CONWAY  
HISTORIC DISTRICT COMMISSION  
STAFF REPORT

# I.A RESIDENTIAL ADDITION - 1621 ROBINSON AVENUE

ASA P. ROBINSON HISTORIC DISTRICT  
 CERTIFICATE OF APPROPRIATENESS REVIEW  
 HOGAN HOUSE - NEW ADDITION  
 1621 ROBINSON AVENUE

Proposed West Elevation

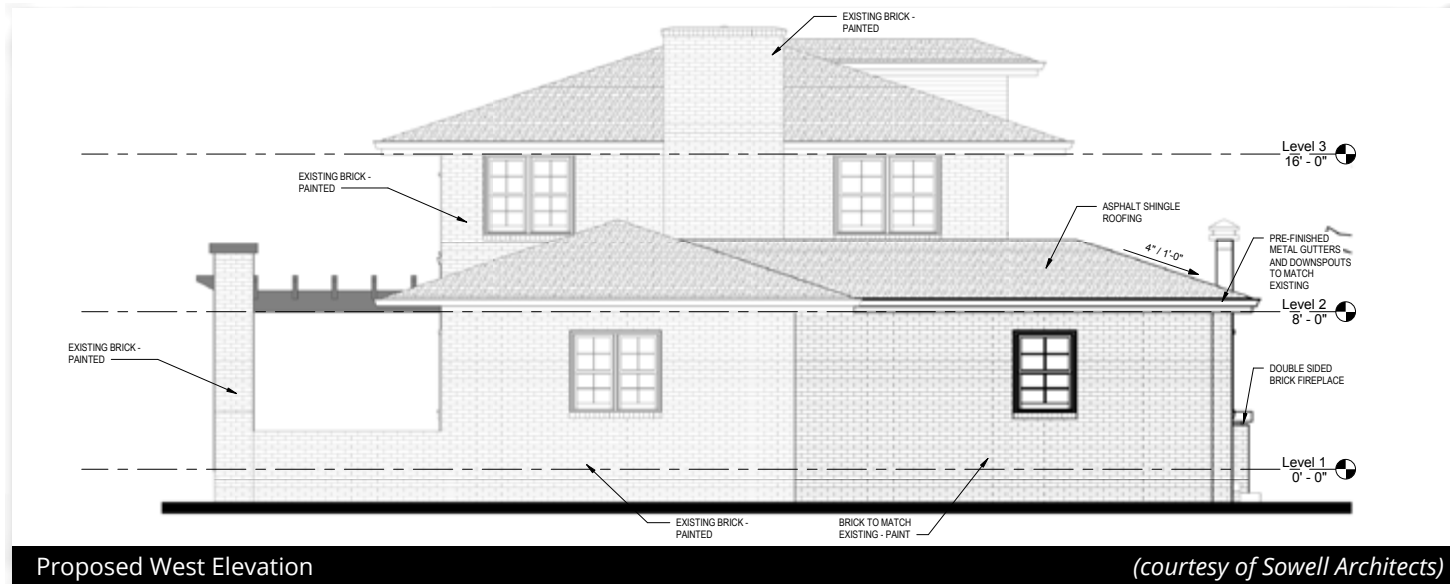
*The applicant's proposal shows "4 over 4" windows with no shutters. It is unclear if these windows are intended to be replaced. However, the existing windows are replacement windows that are not appropriate to the structure. Replacement of the existing windows would be more appropriate than the current windows and would bring the structure closer to returning to contributing status.*

*The proposed addition indicates only one new window on the west elevation. This configuration is not appropriate. Two window openings consistent with window form of the other windows on the west elevation is recommended.*

1. No existing or new brick façade materials may be painted.
2. Two window openings consistent with the window form of the other windows on the west elevation are required on the west elevation of the new addition.

Proposed South Elevation

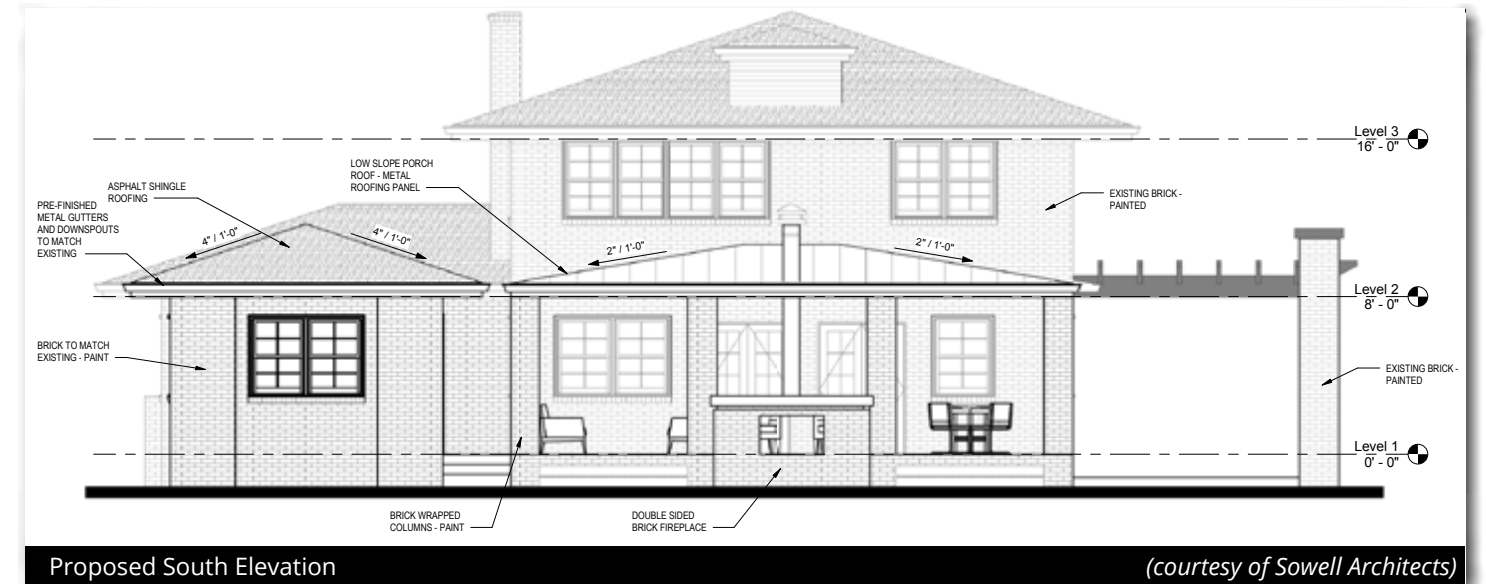
*The proposed porch on the rear will be barely visible from the street, but will not radically alter the character of the existing rear portion of the structure.*

View of front of property along Robinson Ave looking E

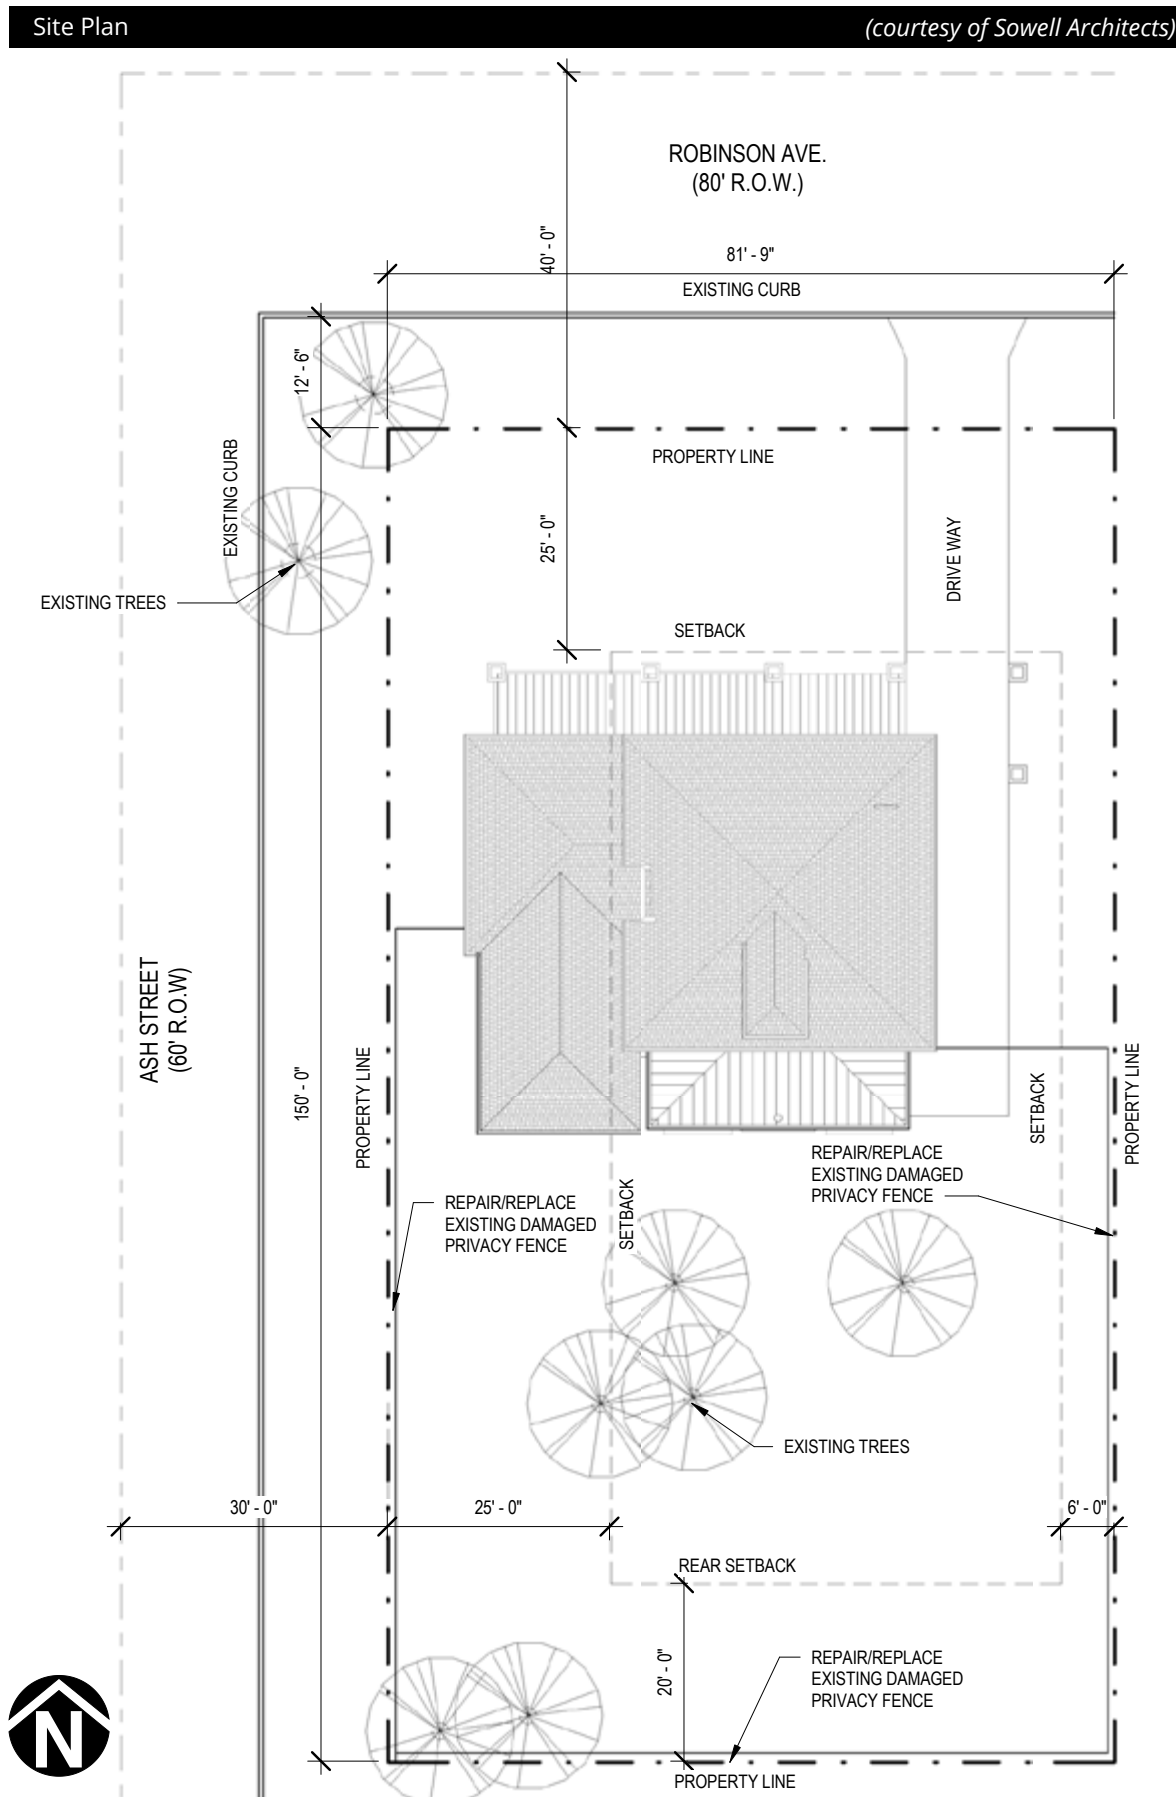
*Sidewalks at the site were removed prior to purchase by the current owner. Though not required, recommend the applicant consider replacement of the sidewalks on Robinson Avenue.*

*The existing concrete walkway between the house and the front of the property is severely damaged. Recommend requiring repair/replacement of the existing walkway.*

3. The walkway between the front of the house and Robinson Avenue shall be repaired/replaced.
4. Applicant is encouraged to replace the sidewalk along Robinson Avenue.
